Approved Septic System Plan
Howard County Health Department

SITE PLAN
SHARP PROPERTY

L.4252/F.247
FOURTH ELECTION DISTRICT, HOWARD COUNTY,
TAX MAP 2, PARCEL 242

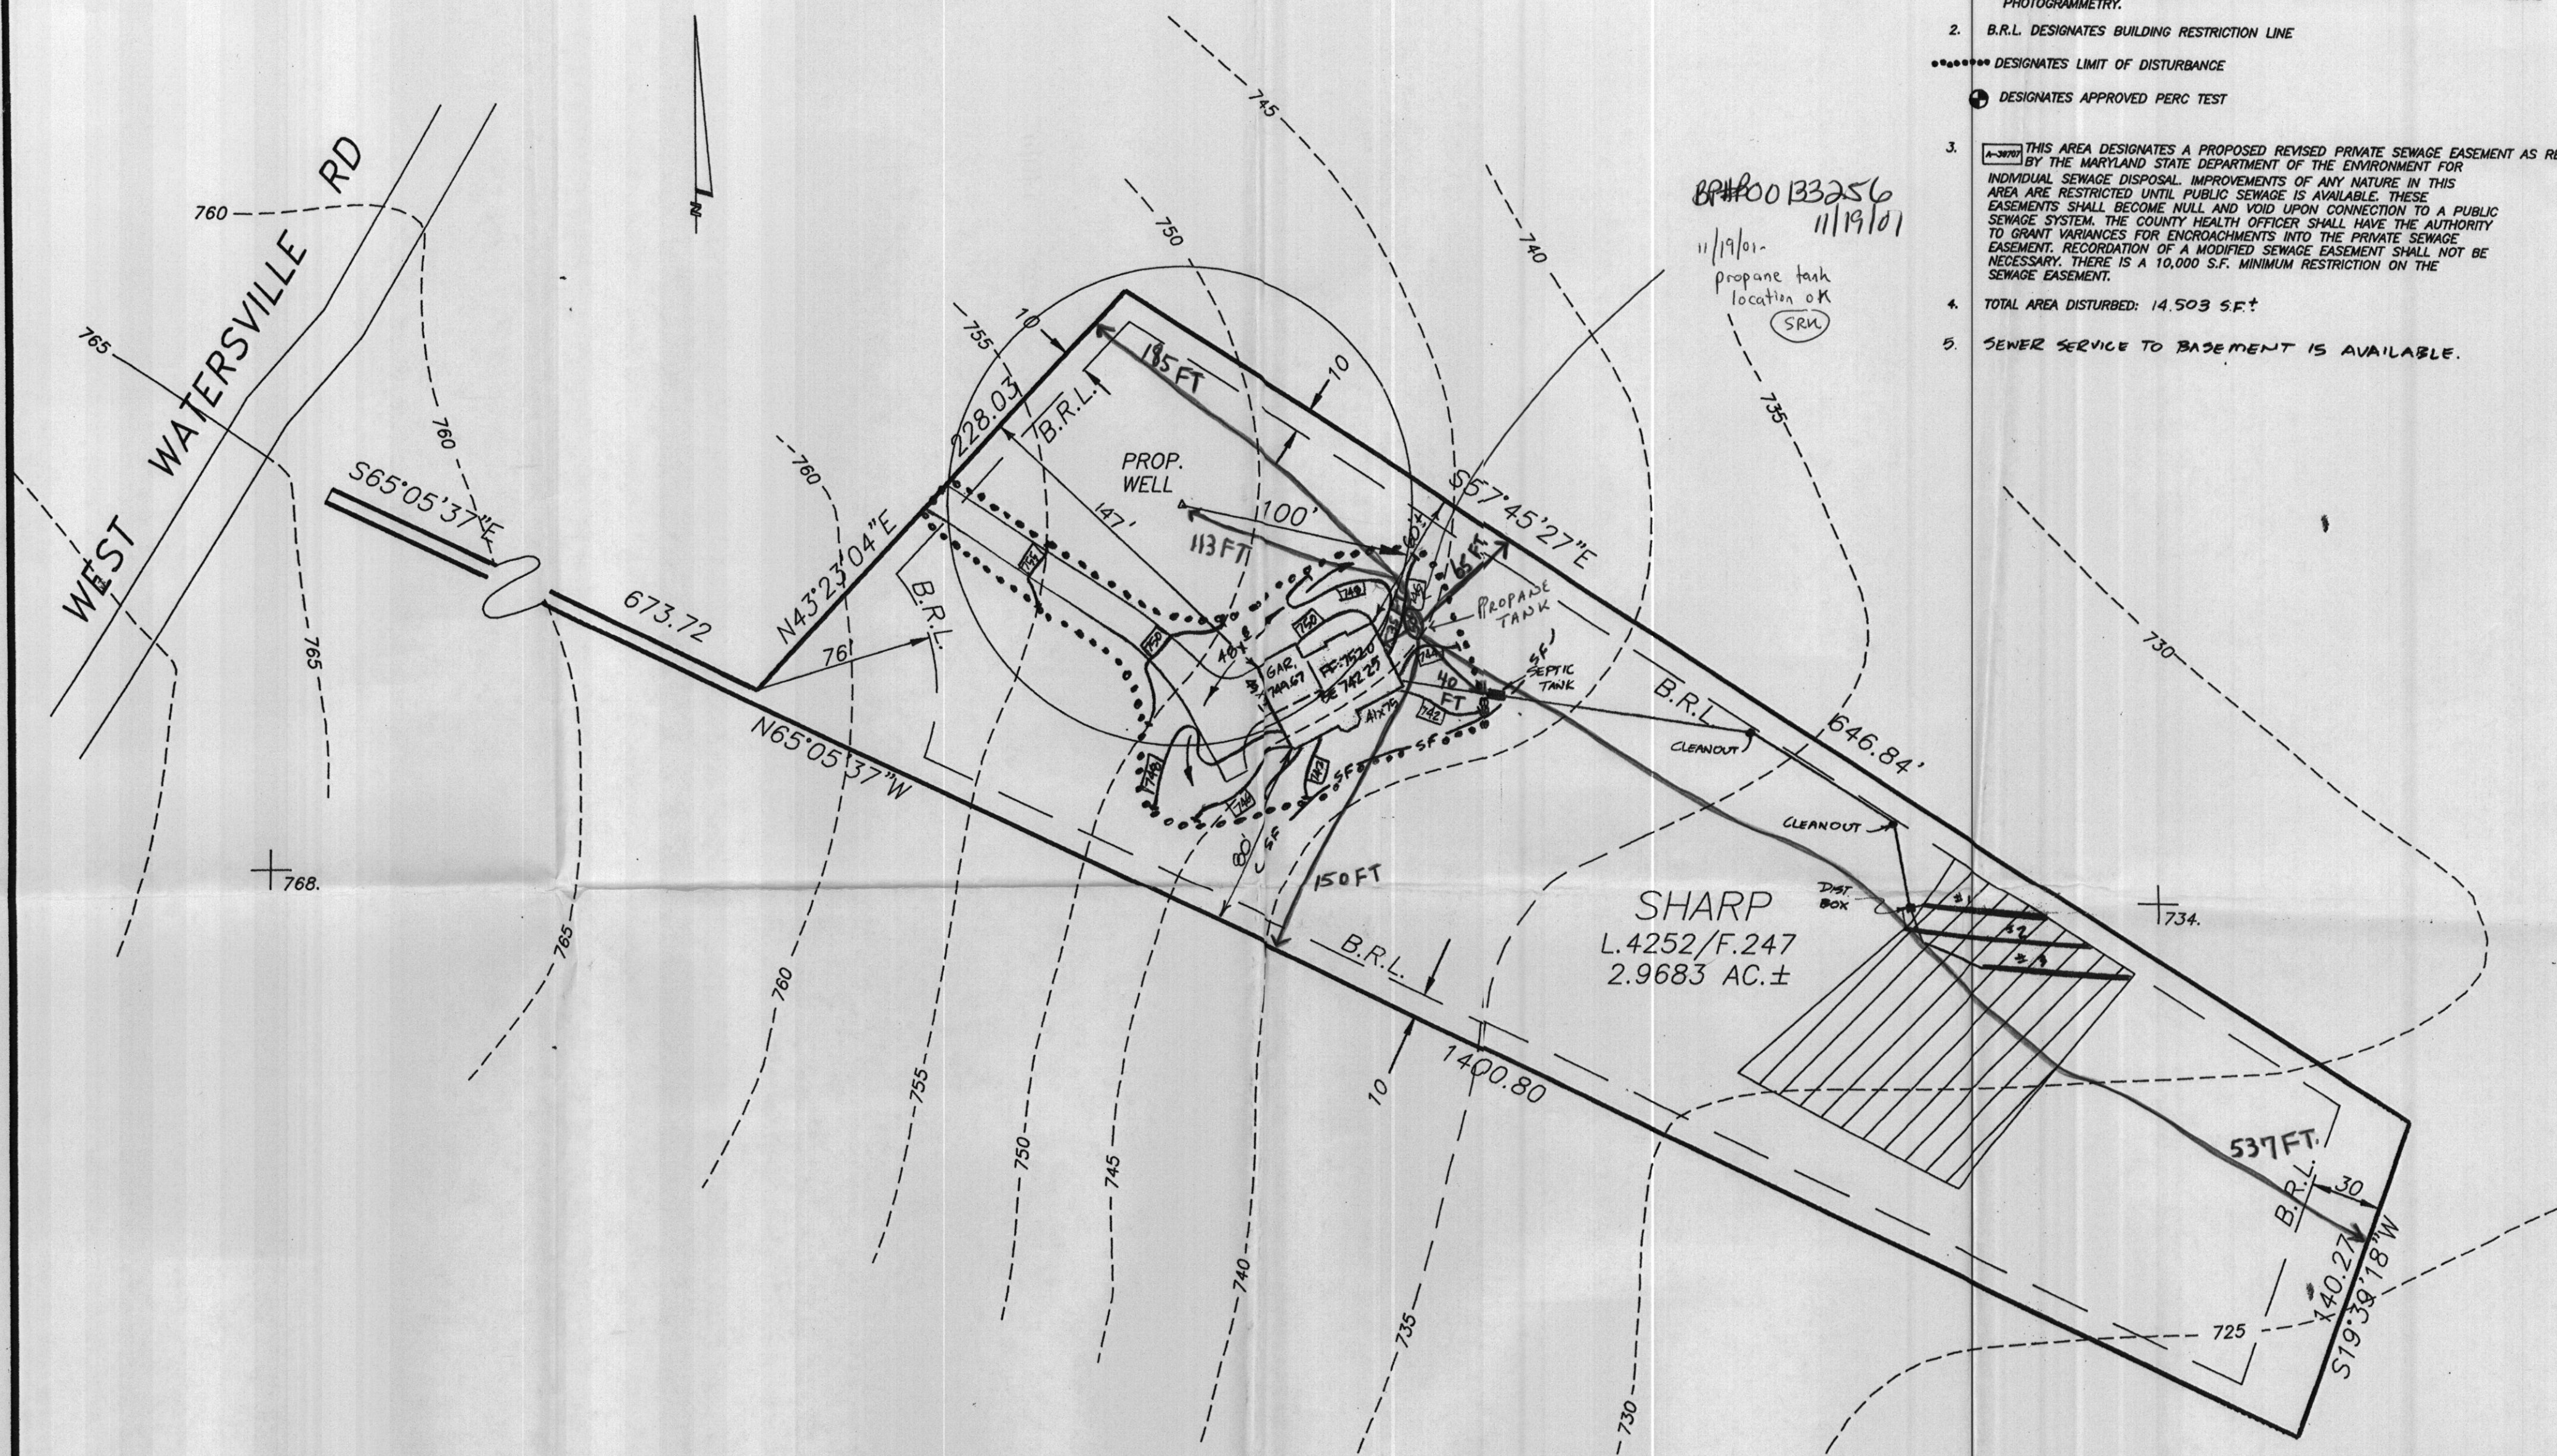
REvised
Date: 5-15-01
Comments: 4-97
West watersville Rd
B00130070
Revised location

11/19/01-
propane tank
location OK
(SRM)
